HISTORIC LANDMARK COMMISSION  
STAFF REPORT

TRACY AVIARY WILSON PAVILION  
RENOVATION, SOUTHERN GROUND  
HORNBILL'S NEW CONSTRUCTION,  
INSTALLATION OF TEMPORARY BUILDING,  
ACCEPT MASTER PLAN  
Major Alterations and New Construction &  
PLNHLC2008-00684  
Liberty Park, 589 East 1300 South  
August 5, 2009

# Tracy Aviary Master Plan Site Plan: Phase II

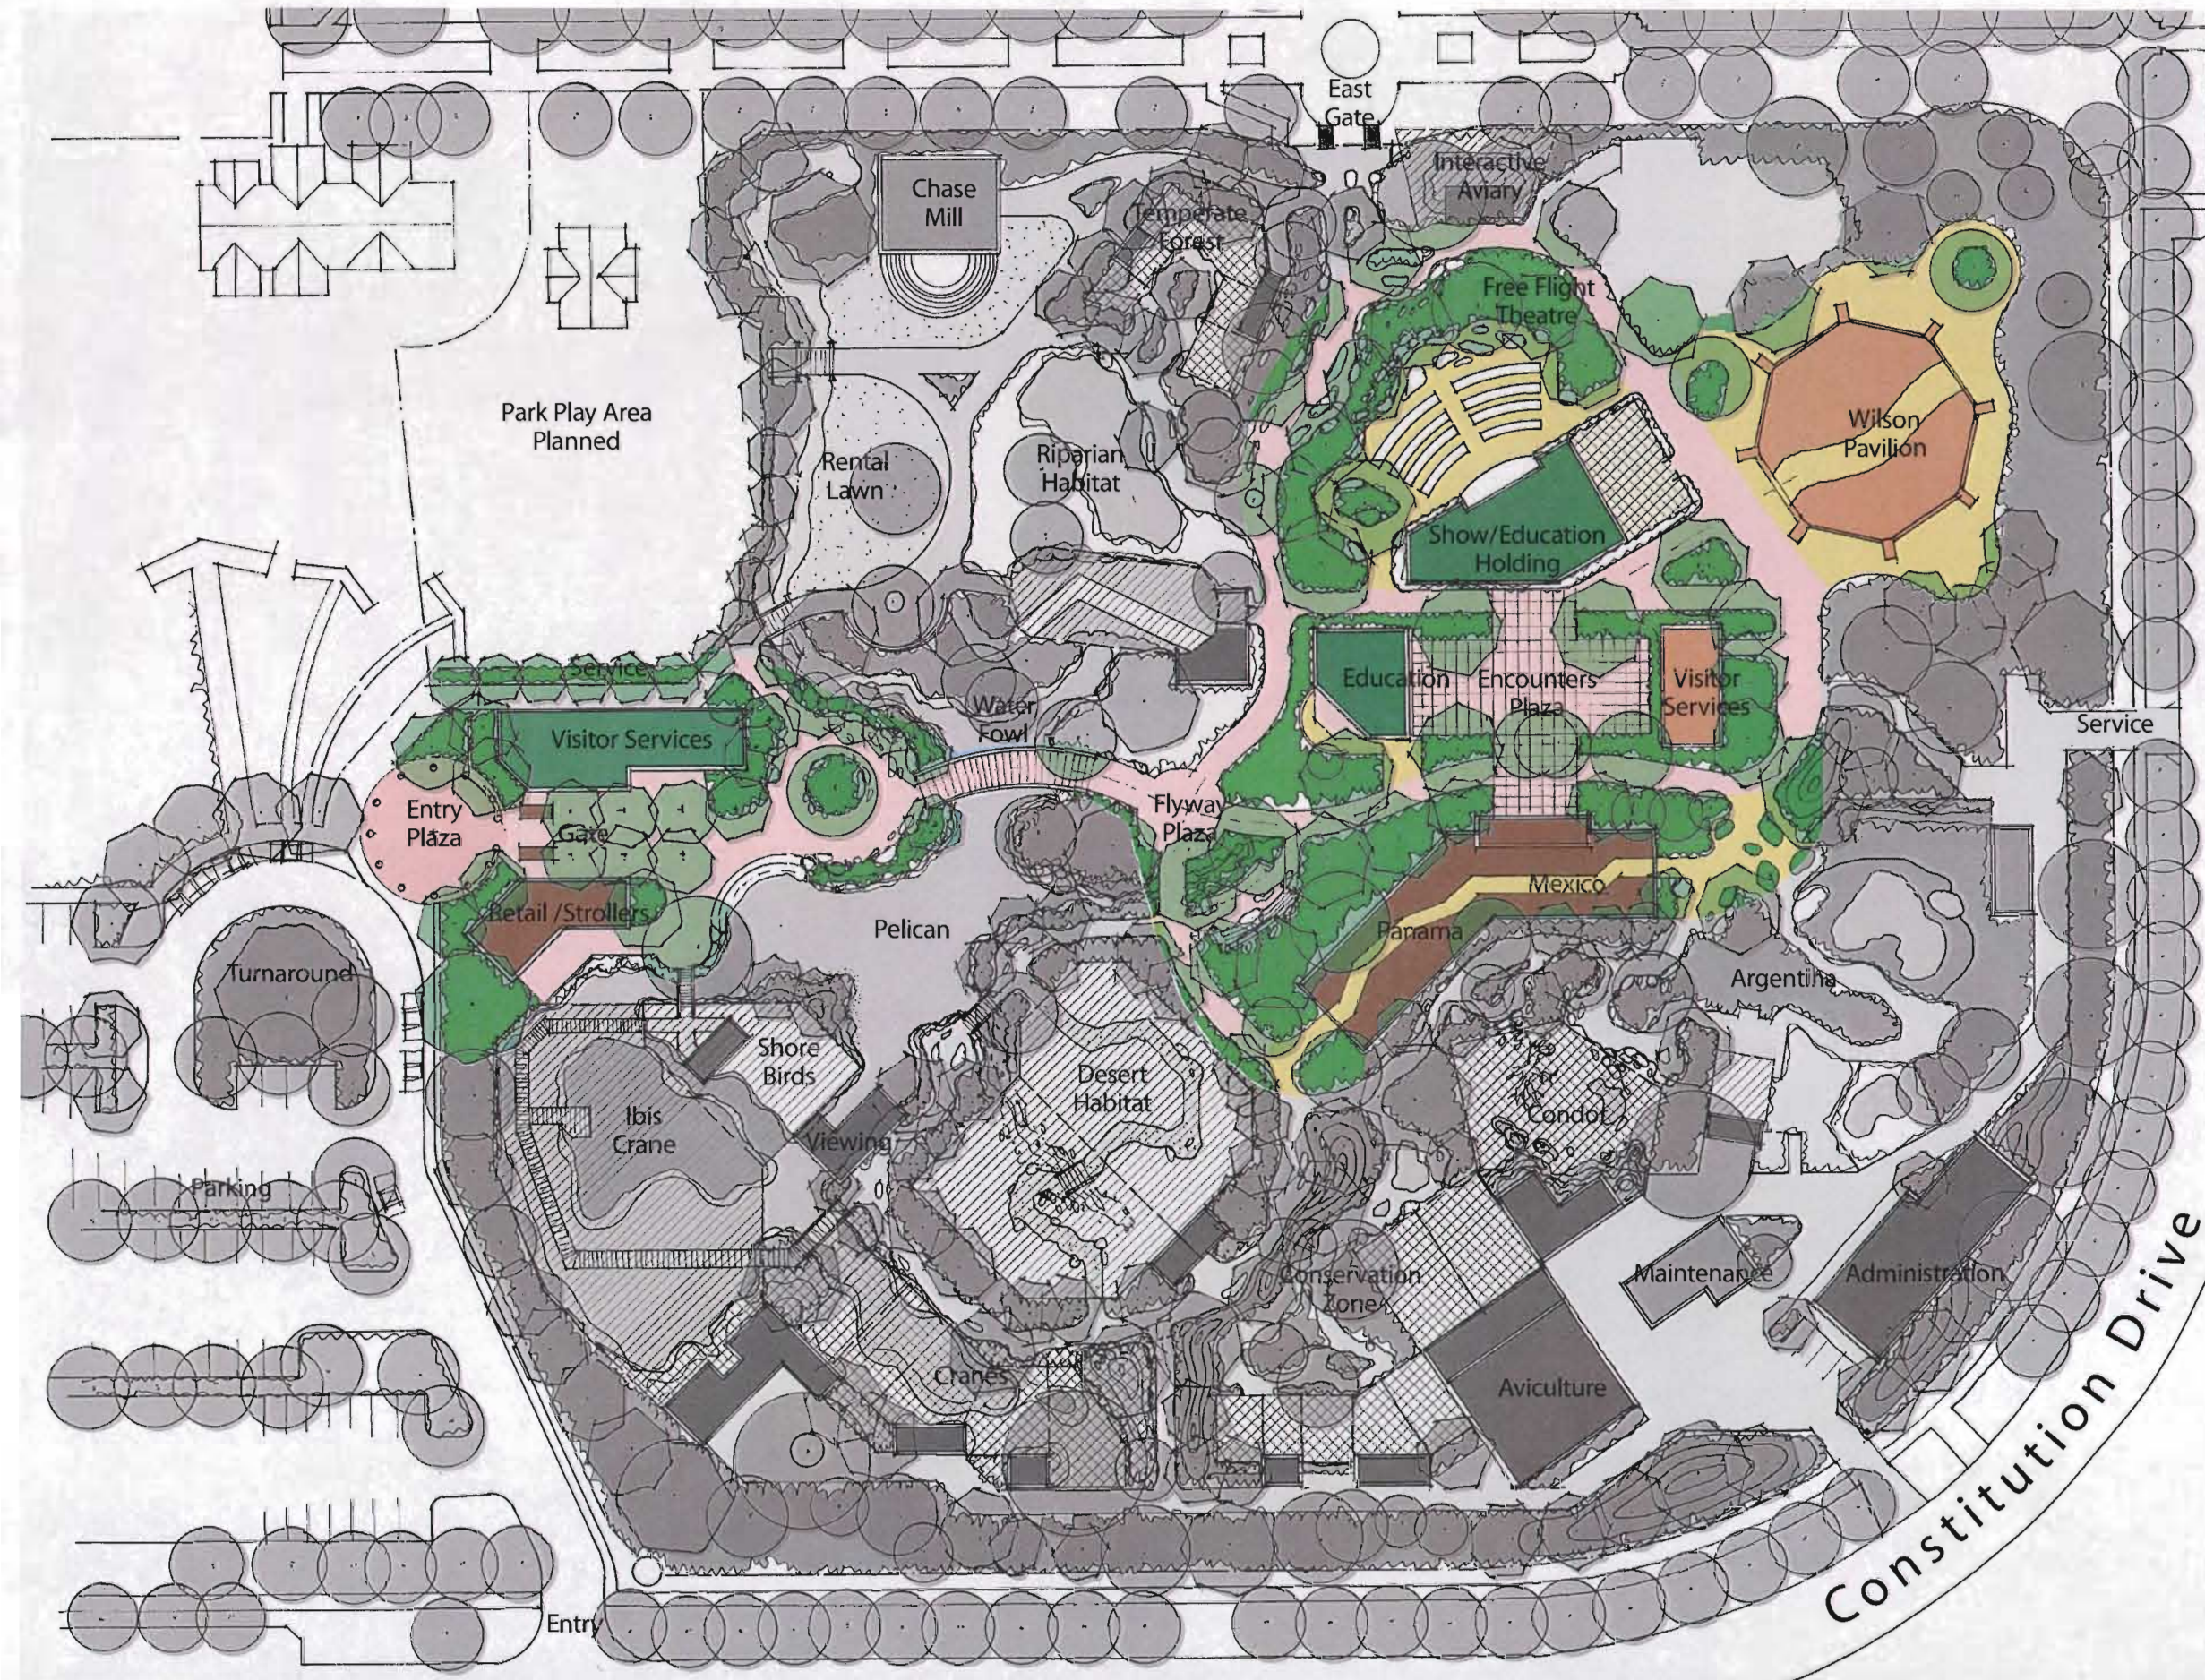
#	Name	Construction date	Recommendation
10.	Burrowing owl exhibit	c. 1938	Although this is one of the early zoo buildings, this structure appears to have undergone multiple changes including the relocation of windows and doors, which undermines its historic integrity. Staff recommends approval of demolition.
14	Southern Ground hornbill exhibit	c. 1970	This structure does not appear on the 1968 plan for the site. It helps to tell the story of development in the Aviary in the 1960s and 70s and does not appear to have undergone major changes. However, research has not revealed any information on its original use and it is probable that the structure does not meet the “exceptional significance” standard of the ordinance for properties younger than 50 years. If demolition is approved, staff recommends documentation following the State Historic Preservation Office’s requirements of Intensive Level Survey.

16	Office/Aquarium	c. 1938	This structure is the most intact and significant of the few structures remaining from the time when the Aviary served as a

<p>zoo. The 1938 and 1968 plans show it as an L-shaped building. It may be appropriate to move this structure to a location in the central portion of the Aviary, if necessary. In 1938, the central portion of the site was the location of the majority of the structures which were centered around an interior drive. Staff recommends interpretive signage for this building and the “feed house” which would provide a short history of the site and its transition from zoo to aviary, as well as these specific buildings. The applicant may wish to work with the Utah State Historic Preservation Office on the design and content of the marker.</p>
17	Shed	c. 1938	<p>This building was a “feed house” in 1938. If the Office/Aquarium is moved, this structure should move with it. Staff recommends retaining this structure within the central portion of the Aviary.</p>
20	Duck pond	c. 1968	<p>This feature has undergone several changes and is in extremely poor condition and so no longer has historic integrity. At the July 2009 meeting, the Commission recommended documentation of this feature before removal. Staff recommends the documentation follow the State Historic Preservation Office’s requirements of Intensive Level Survey.</p>

25	Turkey vulture exhibit	c. 1968	<p>This structure helps to tell the story of development in the Aviary in the 1960s and 70s and does not appear to have undergone major changes. However research has not revealed any information on its original use and it is probable that the structure does not meet the “exceptional significance” standard of the ordinance for properties younger than 50 years.</p>
30	Holding/storage	Not shiplap siding	<p>The date of this building is unknown. Although it follows the general design of other small red sheds on the site its siding material is different-- lapboard siding rather than shiplap. It is estimated that this building was constructed in the last twenty years and is therefore not historic. Staff</p>

recommends approval of demolition.
32	Old bridge	c. 1938	The existing concrete bridge (outside of the current Aviary) and the existing wood bridge appear on the 1938 plan. Although, the wood bridge is not likely usable for guests it may be a historic feature worth preserving. Additional assessment of the bridge is necessary to determine its condition and whether or not it is the bridge shown on the 1938 plans. Staff recommends retaining the concrete bridge.

1. New Construction of a Southern Ground Hornbills exhibit
2. Renovation of the Wilson Pavilion
3. Installation of temporary building
4. Accept Master Plan Phase II with the following conditions:
  - The duck pond and Southern Ground Hornbills building be documented following the State Historic Preservation Office's requirements for Intensive Survey prior to removal;
  - The office/aquarium and feed building be retained and interpreted;
  - The wood bridge be assessed for integrity and historic significance; and
  - All other buildings noted on the June 2009 inventory as planned to be removed are appropriate to remove, if necessary.
